CITY COUNCIL MEMORANDUM

SUBJECT: PLAT22-0021 Consideration of a request from Windrose Land Services for a replat of Lots 3R, 3R1, and 3R2, Holder Smithfield Estates, being 2.399 acres located at 8609 Timber Drive.

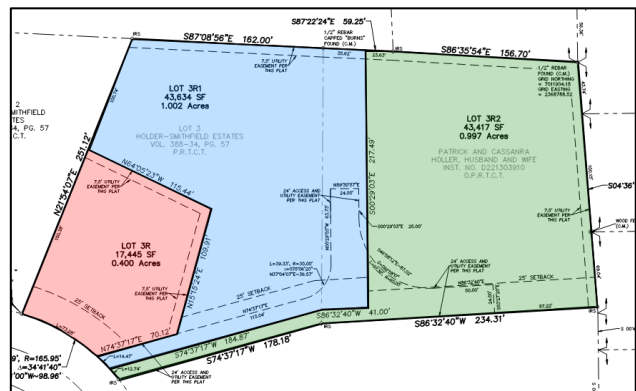
The exhibit to the right shows the proposed lot arrangement. Lot 3R has 73 feet of frontage on Timber Drive. The other two lots (Lots 3R1 and 3R2) are proposed as flag-shaped lots that have 14.5 feet and 12.7 feet of street frontage. While flag-shaped lots are permitted, the zoning ordinance and subdivision regulations require that this type of lot provide at least 50 feet of frontage on a public street. These two proposed lots do not meet the minimum lot frontage standard, and the owner is requesting a waiver of the standard to approve the lots as presented.

During the review of the plat, the Development Review Committee (DRC) discussed the effect that the proposed lot arrangement would have on the property. It was noted that the existing property only has 100 feet of street frontage, which is generally not sufficient frontage for more than one standard lot zoned R-1 (Single-Family Residential). In addition, the DRC discussed concerns about how the three-lot arrangement would affect driveway spacing, water meter locations, the length and location of water and sanitary sewer service lines, mail delivery, and trash collection.

After evaluating this proposal, the DRC recommended denial of the three-lot lot plat as proposed to the Planning & Zoning Commission. The DRC would support a two-lot plat with a waiver for one lot to provide 25 feet of street frontage due to the unusual shape and depth of the existing property. The attached DRC comments include the recommendation for the replat to only include two lots, with the common lot line coinciding with the existing tract boundary. Since the existing property has approximately 100 feet of street frontage, this would be equivalent to dividing the property into two lots, each with the minimum required 50 feet of street frontage.

DRC REVIEW & RECOMMENDATION: The Development Review Committee (DRC) recommends denial of the three-lot plat as presented. Alternatively the DRC would recommend approval of a two-lot plat with a waiver of the street frontage standard for one lot.

Approve PLAT22-0021 as a three-lot plat with a waiver to the street frontage requirements and all other conditions outlined in the Development Review Committee comments.
